ONTARIO STREET (REGIONAL ROAD 42) FROM LINWELL ROAD TO WELLAND AVENUE/ FOURTH AVENUE (REGIONAL ROAD 77) MUNICIPAL CLASS EA

Public Information Centre #2 Summary Report – June 11, 2026

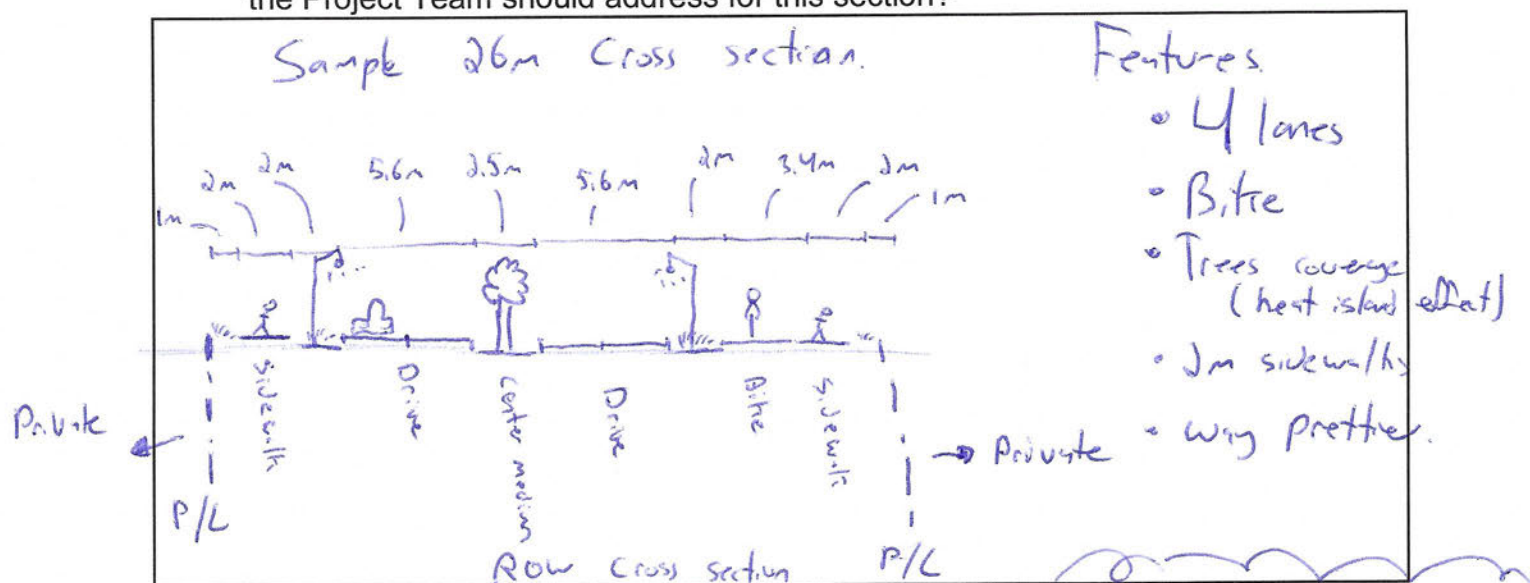
1. Potential for Roundabouts at Carlton + Ontario and Scott + Ontario, plus median all the way through.
2. Reduce to 1 lane each way + a periodic turning lane.
3. Bike lanes, trees in Bkls. middle median + wider sidewalks.
4. Goals → easier to walk, safer to walk.
 - more beautiful
 - safer to drive, reduces T-Bone collisions
 - forces right turns only. No left turns.
